Beeston Civic Society

Objection to 22/00125/FUL

Beeston and District Civic Society OBJECTS to 22/00125/FUL for the following reasons:

22/00125 Sunpath Analysis

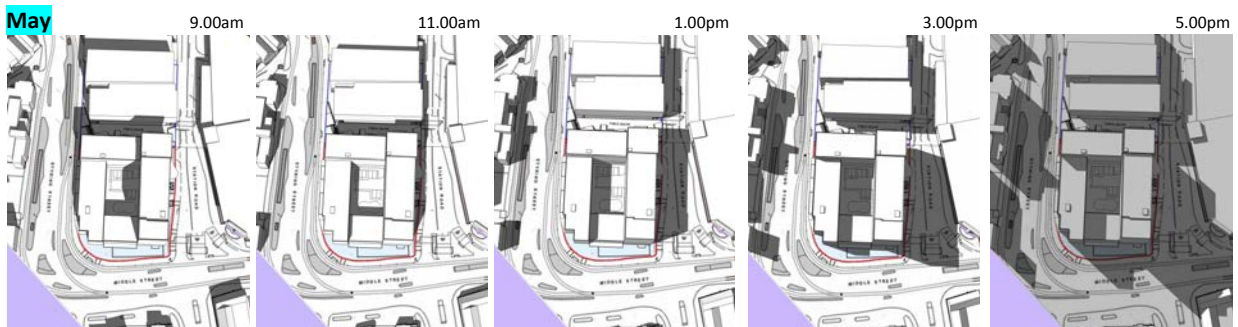
The sunpath analysis included within the proposal does not comprehensively show impact on public and private realm. Here is our sunpath analysis:

Note how the public realm is in shadow except for a brief period between 2pm and 3pm. The social area of the central court is in permanent shadow.

Note how the public realm space is only directly sunlit between 12.30pm and 3.15pm. The social area of the central court is in shadow except between 12.30 and 3.00pm.

Exploration of 22/00125 Proposals

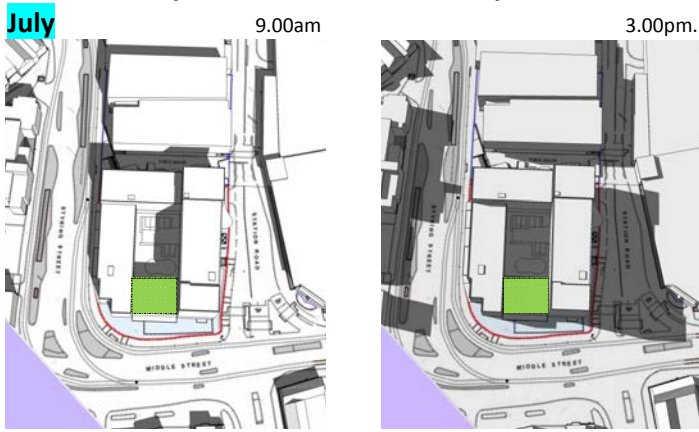
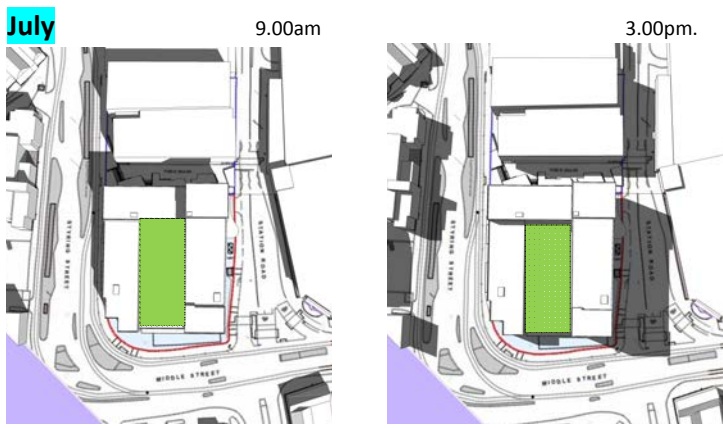
This shows the difference between approved proposal and the current proposal, with attention given especially to the reduction of sunlight and amenity space from loss of the podium.

This illustrates how the 19/00816 proposal included significant useable podium amenity space and greater car parking capacity.

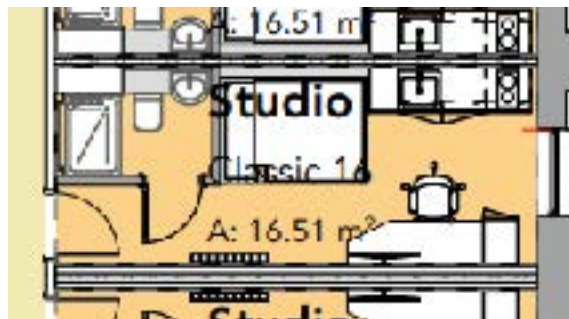
26. As at least 50% of the student accommodation faces the street, it is suggested that the number of rooms which will require mechanical ventilation and heat recovery will be significant.

27. The EESS does not contain a full BRUL Output Document so it is unclear what proportion of student accommodation has been modelled with full MHVR and what proportion has been assumed to be naturally ventilated. BRUL data was submitted with 18-00360-FUL for the cinema / restaurant proposal and it is suggested it might be reasonably expected to accompany this application to and that further clarification is generally required in respect to energy performance and overall strategy.
